Project	<b>IEEE 802.16 Broadband Wireless Access Working Group</b> < <a href="http://ieee802.org/16">http://ieee802.org/16</a> >
Title	<b>Clarification on multicarrier handover</b>
Date Submitted	<b>2009-02-27</b>
Source(s)	<b>Hyunjeong Kang, Jaehee Cho</b> <a href="mailto:hyunjeong.kang@samsung.com">hyunjeong.kang@samsung.com</a> <b>Samsung Electronics</b>
Re:	Change request to the 802.16m SDD (section 19)
Abstract	This contribution proposes to clarify multi-carrier handover operation in 802.16m SDD.
Purpose	For review and discussion in 802.16m
Notice	<i>This document does not represent the agreed views of the IEEE 802.16 Working Group or any of its subgroups. It represents only the views of the participants listed in the "Source(s)" field above. It is offered as a basis for discussion. It is not binding on the contributor(s), who reserve(s) the right to add, amend or withdraw material contained herein.</i>

## Clarification on multicarrier handover

Figure xx A general call flow for multicarrier handover

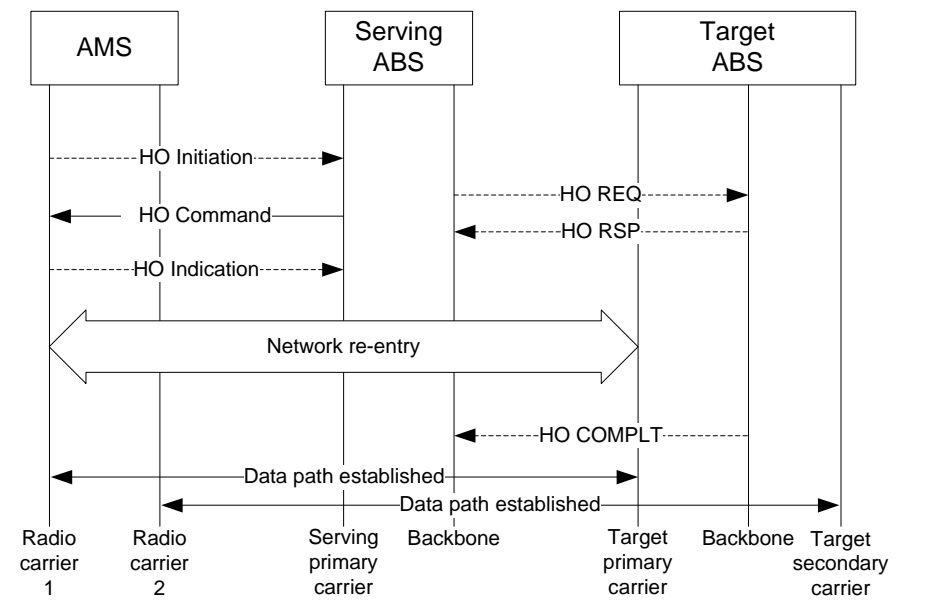
*[Insert the figure after line 11 of page 154 in subclause 19.4.8:]*

Figure xx shows a general handover call flow of AMS with multicarrier capability.
